ADA Curb Ramp New Construction Inspection Form (Parallel)

NW Main

23885.56

NW Lenox

PARALLEL RAMP (PL)

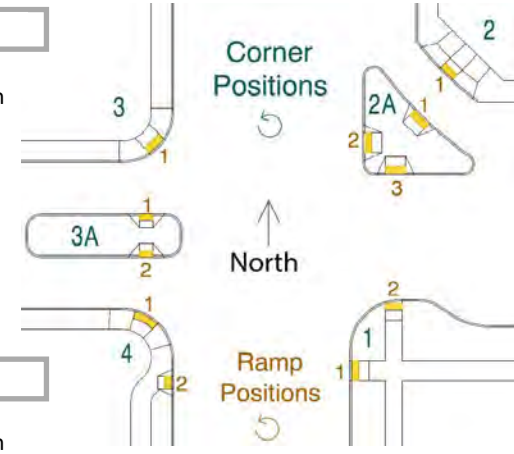
7.9 $\leq *$ ☐ $> *$ ☒

7.8 $\leq |5.0\%|$ ☐ $> |5.0\%|$ ☒

15.4 $\leq 8.3\%$ ☐ $> 8.3\%$ ☒

6.4 $\leq 2.0\%$ ☐ $> 2.0\%$ ☒

3.3 $\leq 2.0\%$ ☐ $> 2.0\%$ ☒

DWS IITD Fails RR 1
